ADDENDUM NUMBER ONE

April 11, 2025

Brookland Sportsplex Phase 2

Brookland, Arkansas

Attachments:
Site Plan, Sheet 2

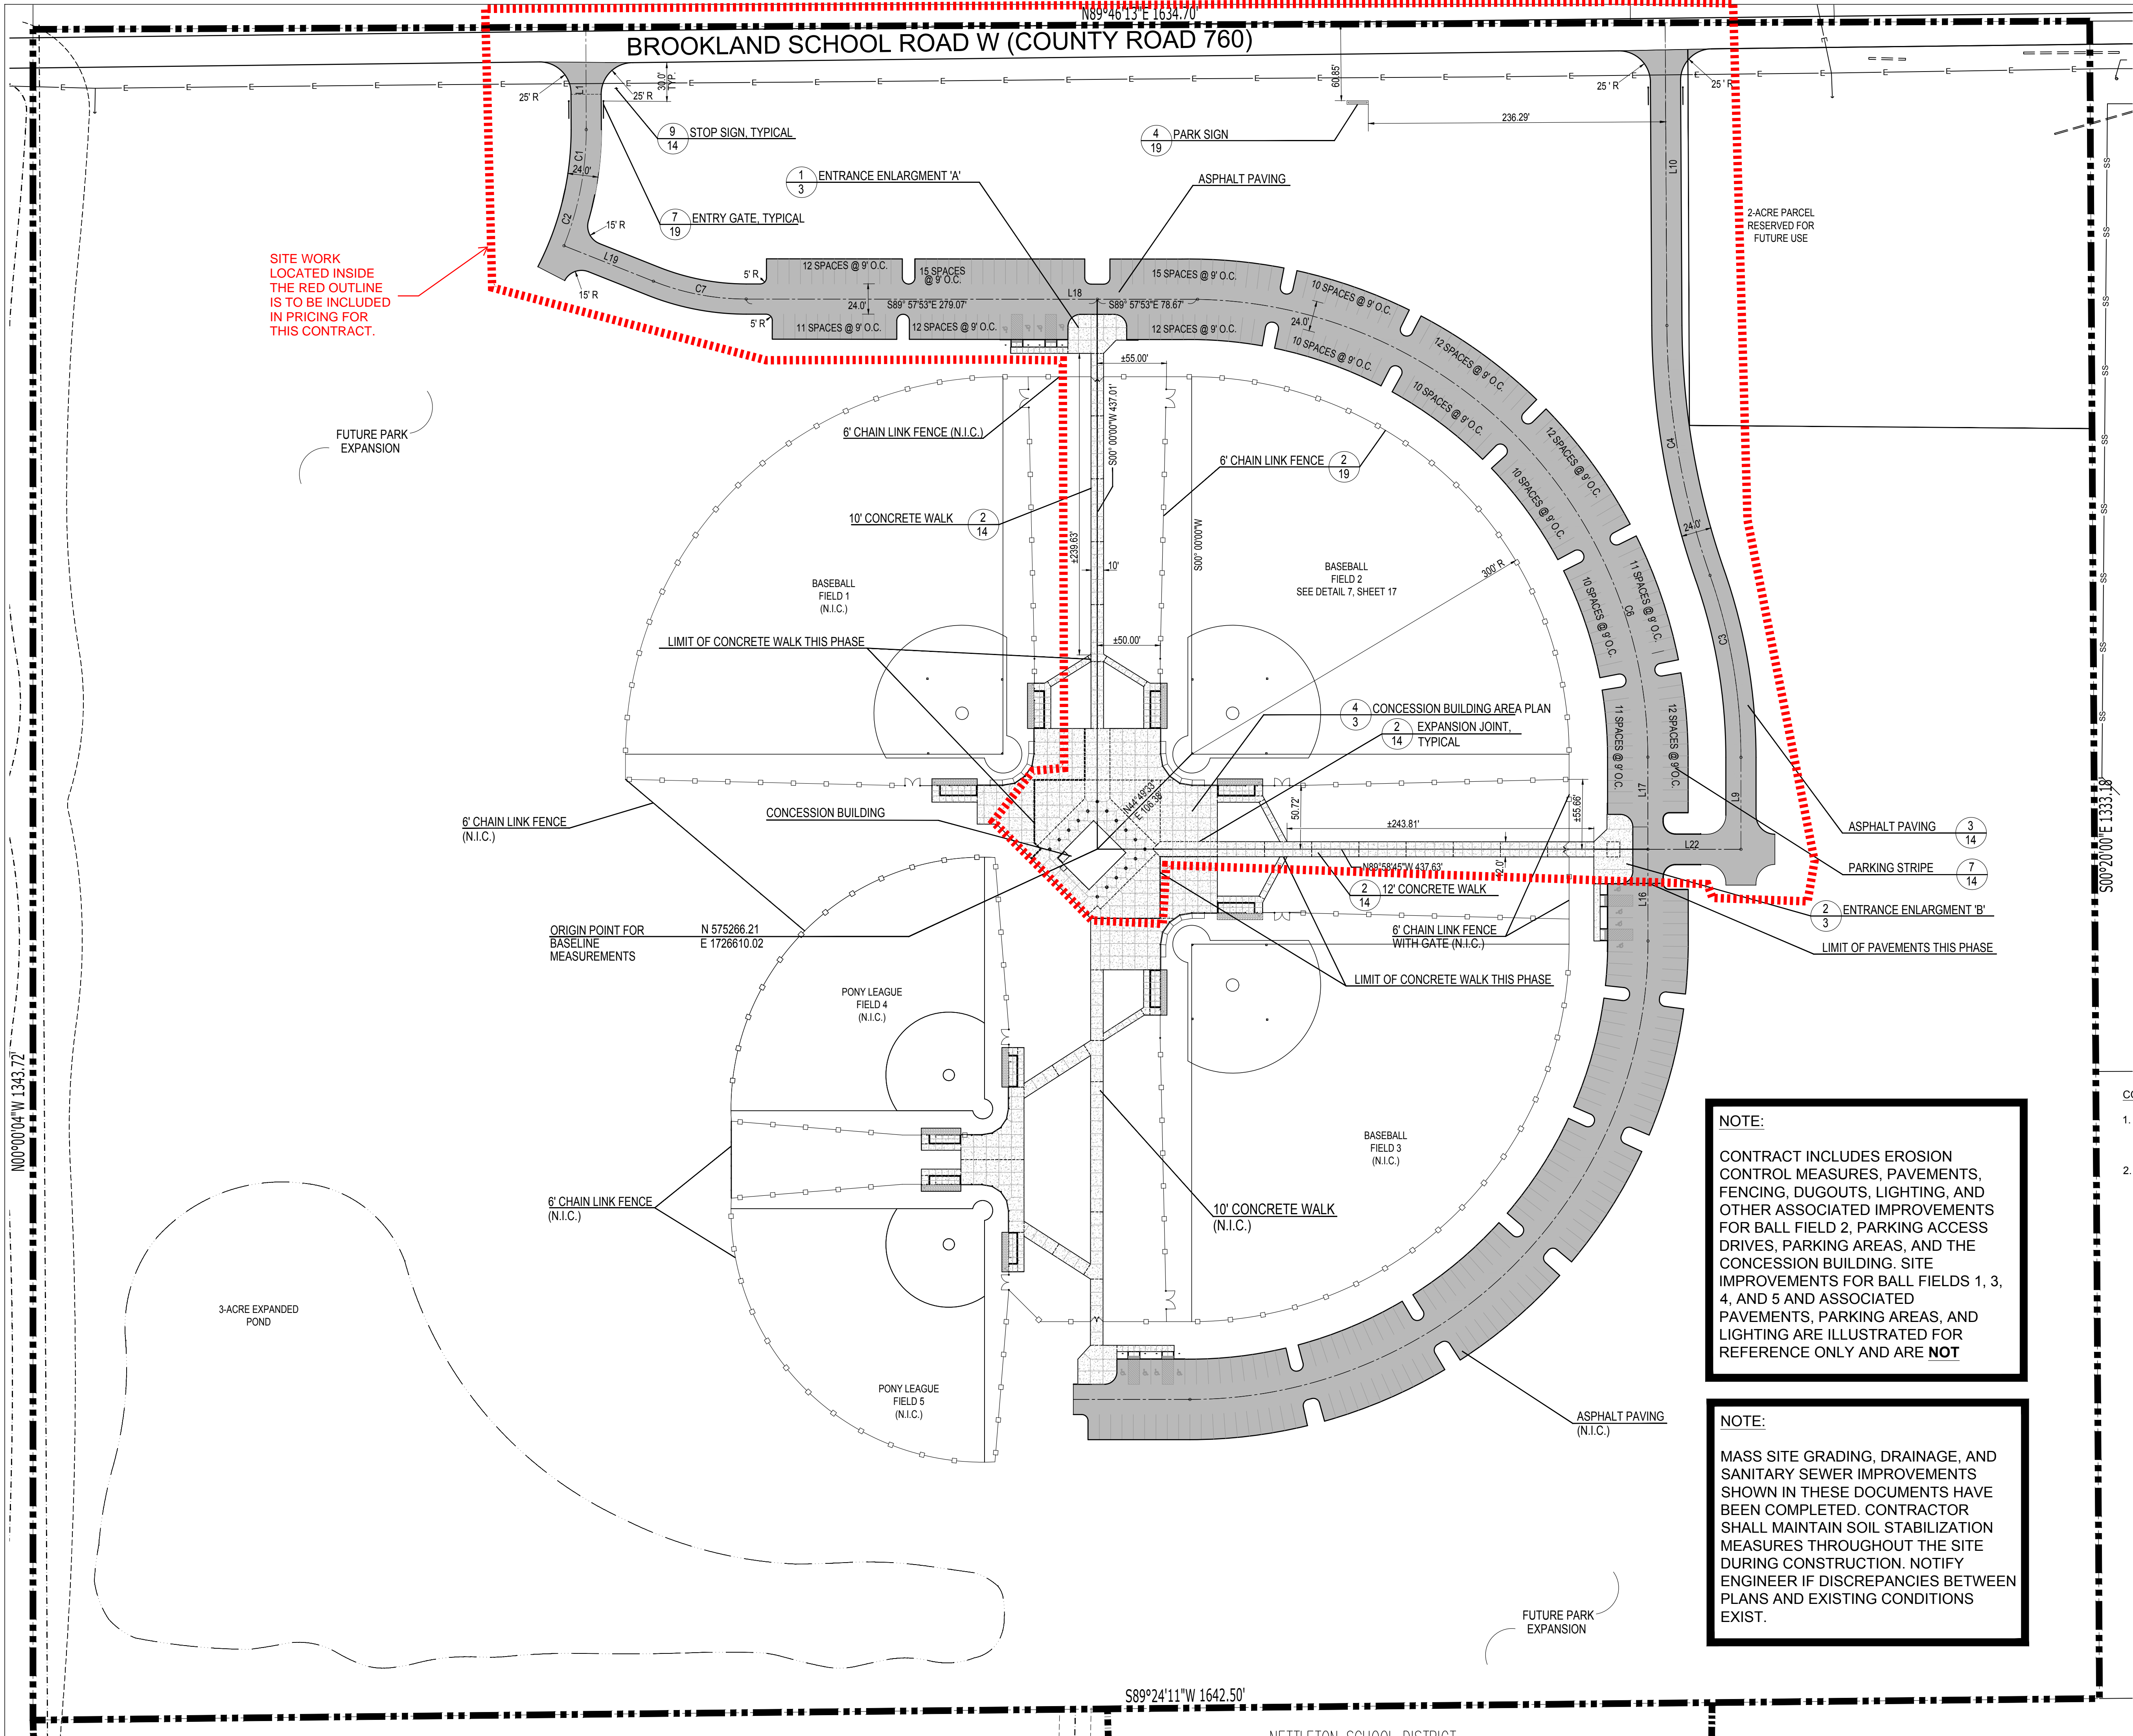
REFERENCE DRAWINGS: Layout Plan, Sheet 2

An updated Layout Plan is attached here, with a red line added to illustrate the extent of the work included in this phase (no revision date).

Question 2. Also, Drawing #4 shows only work needs to be performed in Field #2 but Drawings #5 shows on both field 1 and 2. Please clarify this .

Answer: The extent of the work is illustrated on Sheet 4. Additional information may appear on other sheets in the plan set, but the scope of work shown on Drawing 4 is the extent of the work in this phase. The northeast field (Ball Field 2) is the only one in this bid. It includes lighting, irrigation, backstops, fencing dugouts, etc. For clarity, and updated copy of Drawing 2, Site Layout is included, illustrating the limit of work.

CONTRACT INCLUDES EROSION CONTROL MEASURES, PAVEMENTS, FENCING, DUGOUTS, LIGHTING, AND OTHER ASSOCIATED IMPROVEMENTS FOR BALL FIELD 2, PARKING ACCESS DRIVES, PARKING AREAS, AND THE CONCESSION BUILDING. SITE IMPROVEMENTS FOR BALL FIELDS 1, 3, 4, AND 5 AND ASSOCIATED PAVEMENTS, PARKING AREAS, AND LIGHTING ARE ILLUSTRATED FOR REFERENCE ONLY AND ARE **NOT**
